SUBJECT: Power Shield Tap Block Solder Joints
10CFR Part 21 Report

NOTIFICATION BY: ABB Inc.
Allentown site
7036 Snowdrift Road
Allentown, PA 18106
Dennis Haring
Quality Assurance

Power Shield Tap Block Solder Joints
10CFR Part 21 Report
Attachment A
November 20, 2002

Photo #3

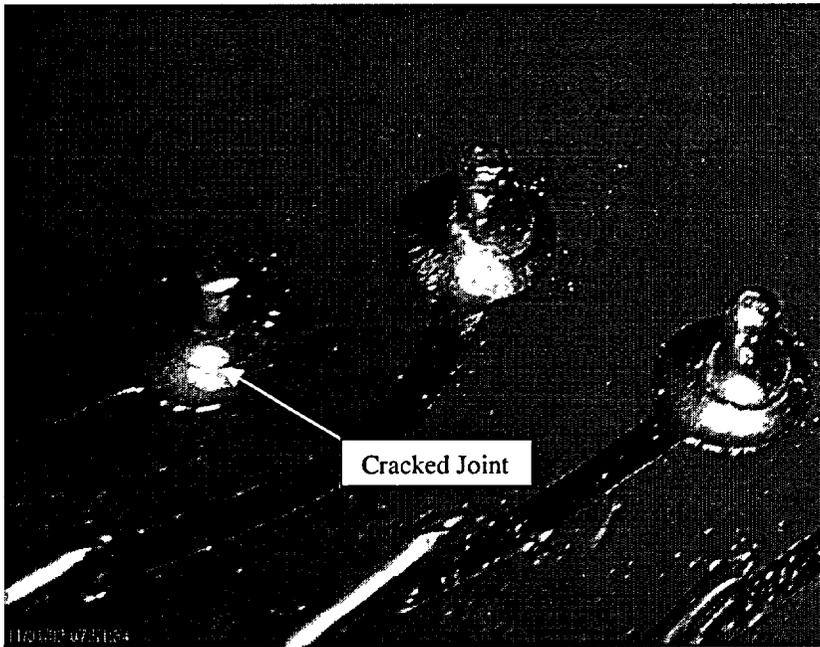
Photo #3 shows cracked solder connections on three tap block pins (underneath tap block).

1. Inspect the solder connections on the tap block pins on the Short-Time / Ground And Long-Time / Inst printed circuit assemblies. Martin Marietta, IPC 610-A-610 Class 3 or the photographs provided by ABB should be used when inspecting these solder connections. All cracked or defective solder connections found, should be repaired by qualified personnel familiar with electronic circuit board repair. ABB Inc. recommends the following method be used:
 - 1a. The defective solder connection must be completely desoldered by using a good quality desoldering tool or solder wick. Care must be used when desoldering the joint as excessive heat will cause the printed circuit pad to

Photo #4

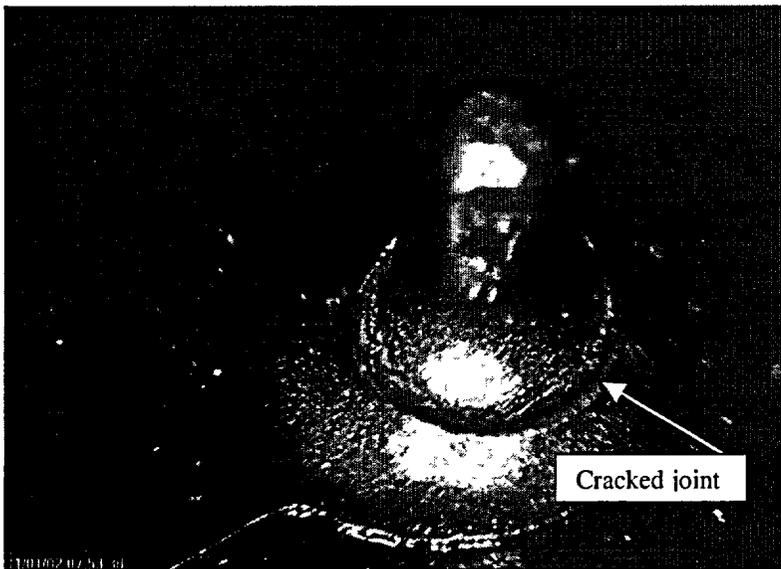
Photo #4 shows a tap block pin solder joint with a 360 degree crack.
